UN#09-389

Subject: UniStar Nuclear Energy, NRC Docket No. 52-016
Response to Request for Additional Information for the
Calvert Cliffs Nuclear Power Plant, Unit 3,
RAI No. 130, Basic Geologic and Seismic Information and
RAI No. 134, Basic Geologic and Seismic Information

**Response to NRC Request for Additional Information,
RAI No. 130, Basic Geologic and Seismic Information,
Questions 02.05.01-33 through 02.05.01-56,
Calvert Cliffs Nuclear Power Plant Unit 3**

Question 02.05.01-41 Figure 1 – Simplified Tectonostratigraphic Map of the Fredericksburg 30' x 60' Quadrangle Map by *Mixon et al. (2000)*

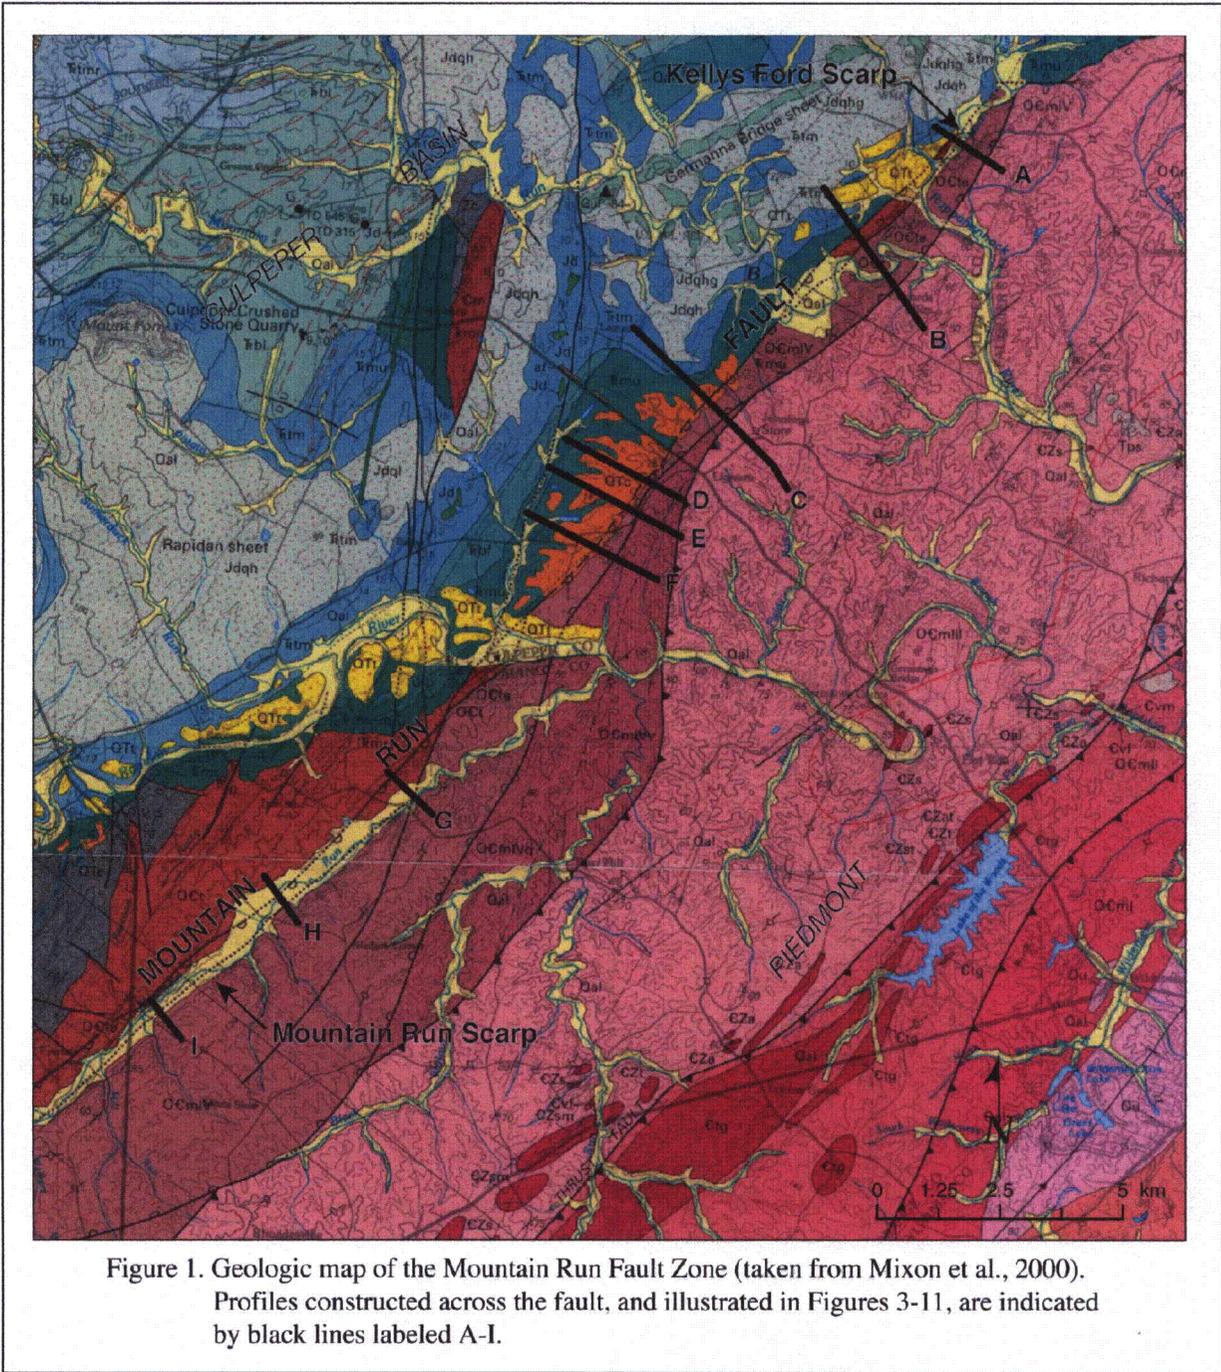
In contrast, the "Everona-Mountain Run fault system" is not industry recognized. The Mountain Run fault zone is a ~75-mile (~120-kilometer) long, broad (up to 4-5 km wide) fault zone containing sheared rocks, phyllonites, mylonites, breccias, and phyllites having fish-scale structure (Pavlides, 1994; Pavlides, 2000). The Mountain Run fault zone as commonly named extends from the south-eastern margin of the Culpeper basin southeastward to at least the small Scottsdale basin near Scottsdale, Virginia (Horton et al., 1991) (FSAR Figure 2.5-16 and revised FSAR Figure 2.5-9). The fault zone dips southeast and is developed within mélangé rocks of the Potomac terrane (including the Mine Run Formation) of the Piedmont province, although locally the zone of shearing extends across the tectonostratigraphic terrane boundary and involves the Blue Ridge (continental margin)-affiliated True Blue Formation strata (Pavlides, 1994; Pavlides et al., 1989; Mixon et al., 2000). A simplified geologic map of this fault zone and cross sections within the Fredericksburg 30' x 60' Quadrangle (Mixon et al., 2000) are reproduced as Figures 1 and 2.

Question 02.05.01-41 Figure 3 – Portion of the Fredericksburg 30' x 60' Quadrangle Geologic Map by Nixon et al. (2000) Showing the Locations of Profiles A through I. This is a Reproduction of Figure 1 in Dominion (2004a).

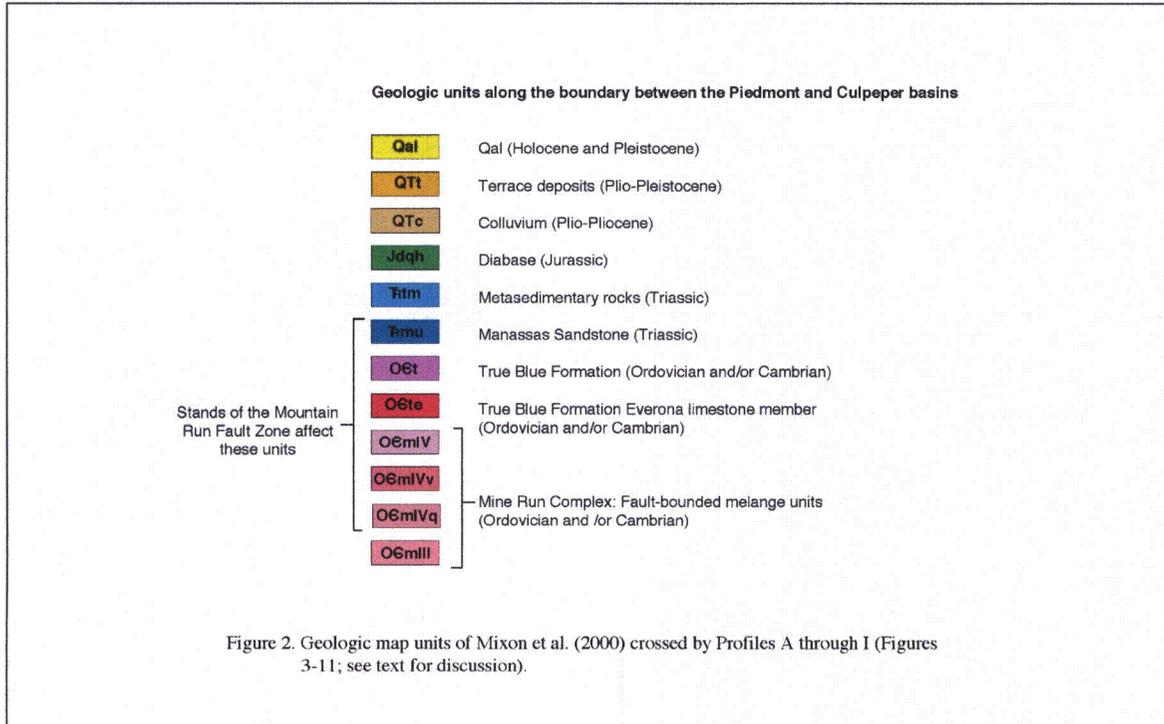
The relevant new figures generated for the North Anna ESP application by Dominion (2004a) that address the scarps include a map and nine profiles; these figures are reproduced here as Figures 3 to 8. Figure 3 (corresponding to Figure 1 of Dominion (2004a)) shows the section of the geologic map by Mixon et al. (2000) that includes the Mountain Run and Kelly's Ford scarps, and the locations of the profiles with simplified geology across the Mountain Run fault zone along and between the two scarps. Figures 5 to 8 show the nine profiles. Profile A (upper profile in Figure 5) crosses the Kellys Ford scarp, and profiles G, H, and I (Figure 8) cross the Mountain Run scarp. Profiles B through F cross the Mountain Run fault zone between the two geomorphic features.

Question 02.05.01-44 Figure 1 – Location of Inner and Outer Ring Growth Faults of the Chesapeake Bay Impact Structure Modified from Figure 7.1.1 of Poag et al. (2004)

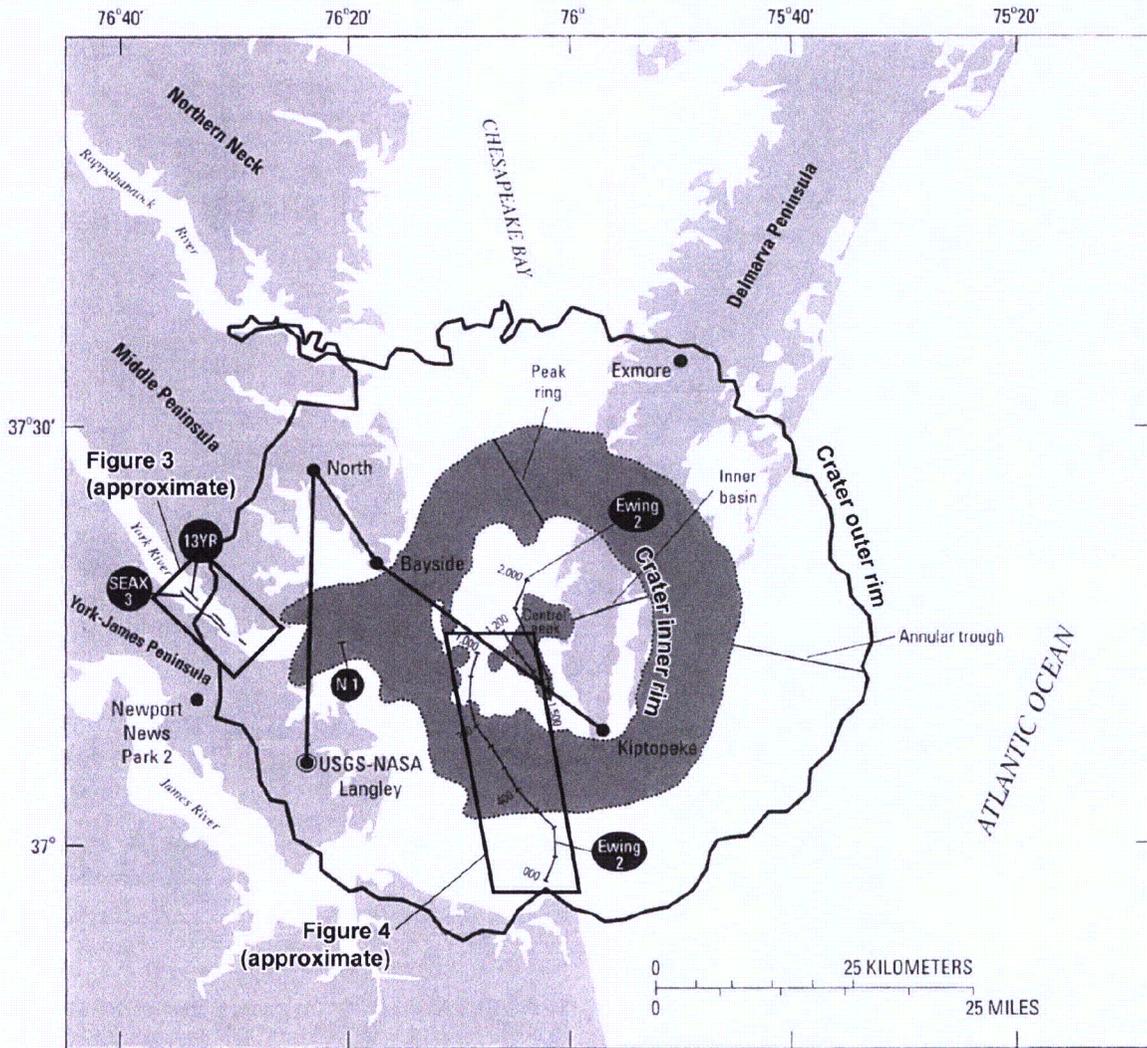
- a. The inner and outer ring faults that are mentioned in the FSAR passage quoted in the RAI question are compaction related growth faults (Figure 1) (Poag et al., 2004). Seismic profiles are used to partly delineate the outer and inner rims of the Chesapeake Bay impact structure (CBIS)(Figure 2). The location of these growth faults as mapped by Poag and Norris (2005) on the Chickahominy Formation horizon (an Upper Eocene marine clay capping impact generated breccia) are presented in Figures 2 and 3. Figure 3 displays an outer ring fault imaged in the York River, whereas Figure 4 shows series of faults located near the inner ring of the CBIS. The growth faults mentioned in the FSAR passage are generally not genetically related to faults within the Proterozoic and Paleozoic crystalline basement rocks that formed at the time of impact (Poag et al., 2004; Powars and Bruce, 1999). The FSAR text will be modified to more clearly make this distinction.

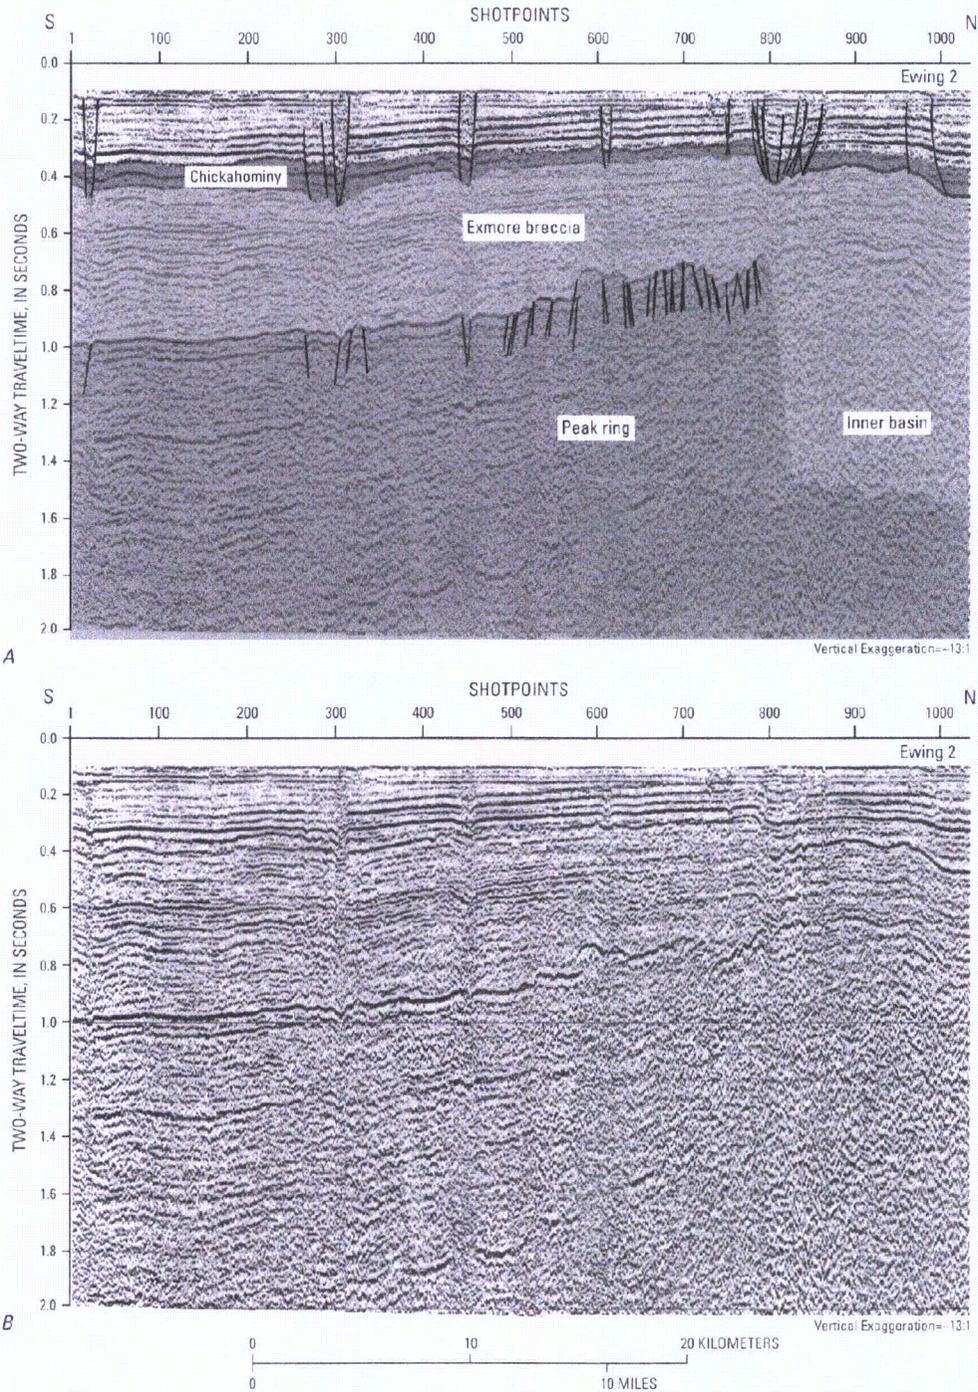
The interpreted seismic profiles show the locations of faults within the impact structure synimpact, basement involved faults (e.g., faults offsetting the crystalline basement), growth faults, and faults accommodating slip between syn-impact displaced megablocks (e.g., faults separating large slump blocks within the pre-impact sediments near the peak ring) (Poag and Norris, 2005). The inner and outer ring growth faults discussed in the RAI question generally occur within the impact breccia and post-impact sediments as shown in Figures 3 and 4.

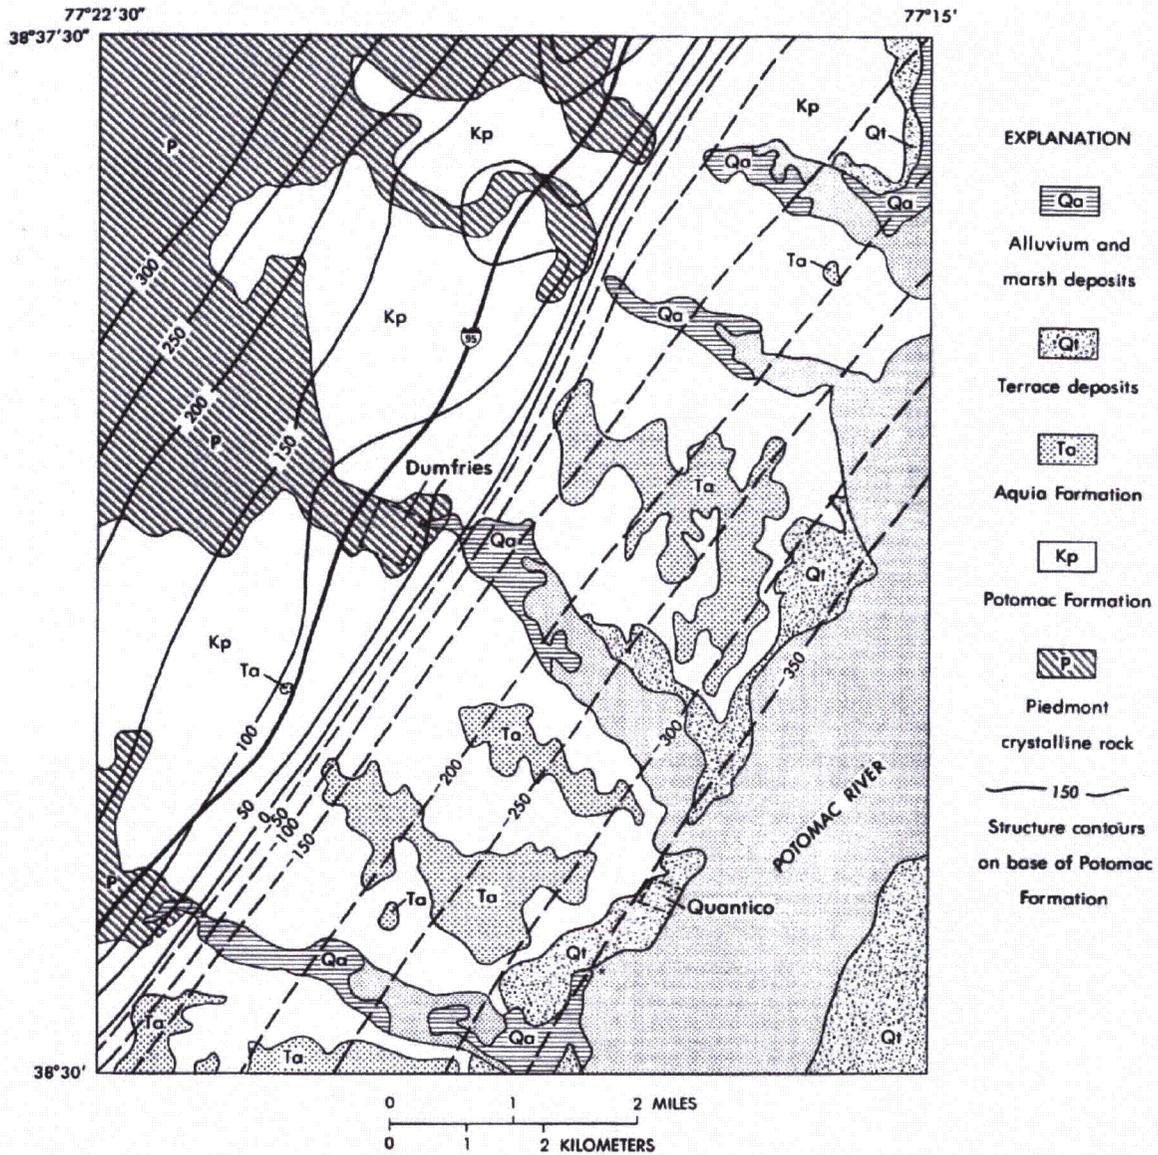
- b. Several faults are identified as part of the Stafford fault system mapped near the Potomac River in Virginia. As discussed in Section 2.5.1.1.4.4.4.1, the faults of the Stafford fault system strike roughly N35°E (Figure 1). From northwest to southeast they are the Dumfries, the Fall Hill, the Hazel Run, the Brooke and its northern extension, the Tank Creek, and an unnamed fault located ~2 miles (3 km) southeast of the Hazel Run fault (Figure 1). They dip steeply to the northwest and offset Cretaceous and Tertiary units down-to-the-southeast, indicating thrust or reverse movement, though some right-lateral kinematic indicators have been found as well. As discussed below, the majority of faulting occurred after the deposition of the Paleocene Aquia Formation and before the deposition of the Miocene Calvert Formation. However, minor Pliocene faulting or deformation is recorded in two exposures.

The Dumfries fault is a 28 mile (45 km) long, northeast-striking, northwest-dipping, rightlateral thrust juxtaposing the Lower Cretaceous Potomac Formation and the Upper Ordovician Quantico Formation (Mixon et al. 1972; Mixon and Newell, 1977; Mixon et al., 2005). Structure contour maps of the base of the Potomac indicate that the unit thins abruptly to the north across the structure and the Dumfries fault marks the up dip limit of the Paleocene Aquia Formation (Figure 2) (Mixon et al., 1977, Mixon & Newell, 1978; 1982). As reported in, Mixon and Newell (1978) a trench excavated near the southern end of the fault revealed thrust and right-lateral kinematic indicators (striations, etc.) in the fault gouge juxtaposing the Cretaceous and Paleozoic units (Trench 1 of Figure 1).

Question 02.05.01-45 Figure 4 – Sketch of South Wall of Trench across Fall Hill Fault, near Falmouth, Virginia. Modified from Pepco (1976), as reported in Mixon and Newell (1982), and Mixon et al. (2005)

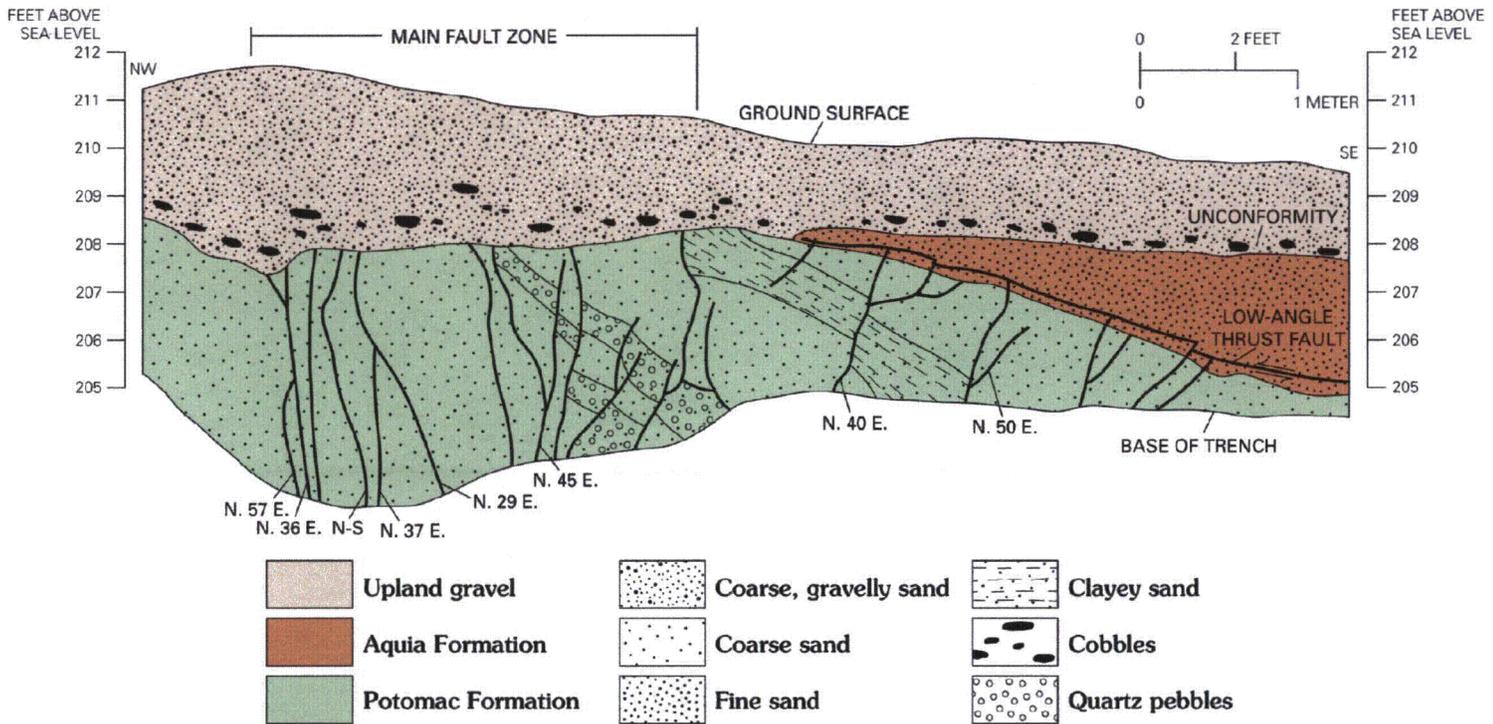
(Mixon and Newell, 1982; Mixon et al., 2000; Trench 2 of Figure 1; Figure 4). While “considerable debate” exists about a potential 1 inch (2.5 cm) offset in the base of the Pliocene Tps above one of the faults exposed at the northwestern end of this trench (Mixon and Newell, 1982), every other fault in the trench terminates in the unfaulted Tps (or upland gravel) contact (Figure 4)(Mixon and Newell, 1982; Mixon et al., 2000). Former roadcut exposures indicated that the base of a Rappahannock river terrace gravel was offset by 11-14 inches (28-36 cm) (see 14 in. Pliocene Terrace Offset in Figure 1) (Mixon and Newell, 1978). However, the age of the gravel is uncertain. It was originally cited as late Pliocene or early Pleistocene (Mixon and Newell, 1978), but it may be equivalent to the Yorktown Formation, which is early and middle (?) Pliocene in age (Mixon and Newell, 1982). Most recent publications indicate these gravels are “of probable Pliocene age” (Mixon et al., 2005) and speculate the offset unit is the upper Pliocene Bacons Castle Formation (Mixon et al., 2000). Faulting is not traceable into the terrace gravel (Mixon and Newell, 1978). Mixon and Newell (1978) also reported that the Thornburg scarp, a Pliocene paleoshoreline, crosses the Fall Hill fault and is undeformed by it. In recent geologic mapping, the Fall Hill fault is shown as dotted or “concealed” where its trace intersects Upper Pleistocene and younger units (e.g., Mixon et al., 2005). The Dominion (2004a) study found that the Pliocene marginal-marine sandy gravel unit (Tps) was undisrupted across the fault (see also response to part e below). Hence, deformation on the Fall Hill fault most likely ended in the Pliocene.

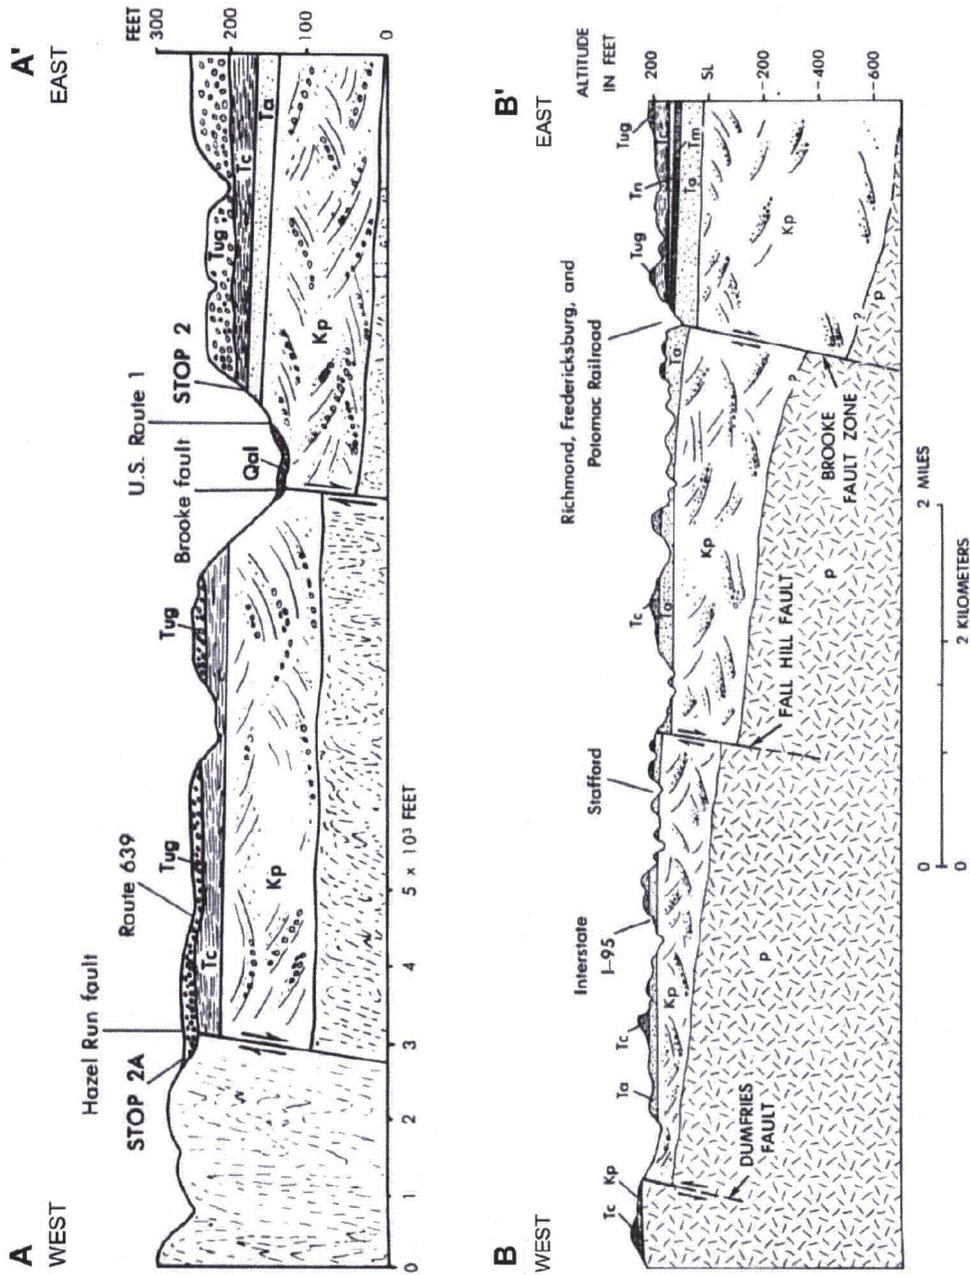
A boring revealed that the vertical separation of the base of the Cretaceous section was roughly 110 ft (33.5 m) (Figure 5) (Mixon and Newell, 1978). The Dominion study (2004a) study found that the top of the Miocene Calvert Formation was undeformed in a transect across the Dumfries fault, indicating that the timing of the Dumfries fault activity was post-Cretaceous and pre-Miocene (See response to RAI 130 Question 45 part e below).

In summary, the structures are northwest-dipping, southeast-vergent thrust faults (Figure 5). The structures displace Cretaceous Potomac Formation and the Paleocene Aquia Formation thins across these structures, indicating Paleocene faulting. The Paleocene to lower Eocene Marlboro Clay and Nanjemoy Formations have been erosionally removed on the upthrown side of the Brooke fault, further indicating early Tertiary faulting (Figure 5). Most evidence indicates that faulting ceased during the Miocene, including (1) borings across the Hazel Run fault that indicate the Miocene Calvert Formation and overlying gravels have not been deformed (Mixon and Newell, 1978); (2) the Miocene Calvert Formation is undeformed across the Dumfries fault (Dominion, 2004a), and (3) a latest Miocene shoreline (the Thornburg scarp) is not offset by the faults of the Stafford fault system (Mixon and Newell, 1978). However, there are two instances that indicate the Calvert Formation, or younger deposits have been faulted. The first is based on an outcrop southeast of the Hazel Run fault where the base of the upland gravels (Miocene or Pliocene) have been offset 18 inches (46 cm) (Mixon and Newell, 1978). The second is an outcrop on the Fall Hill fault where the base of the Pliocene (?) age Rappahannock River terrace deposit is offset 11-14 inches (28-36 cm) (Figure 1, Mixon and Newell, 1978). In neither case is faulting traceable upward into the younger (Miocene or Pliocene) units (Mixon and Newell, 1978), nor does either case require Quaternary faulting on the Stafford fault system. As discussed in FSAR Section 2.5.1.4.5.4.1, the Stafford fault system is not considered a capable tectonic source, and there is no new information that would require a significant revision to the EPRI (1986) seismic source model.
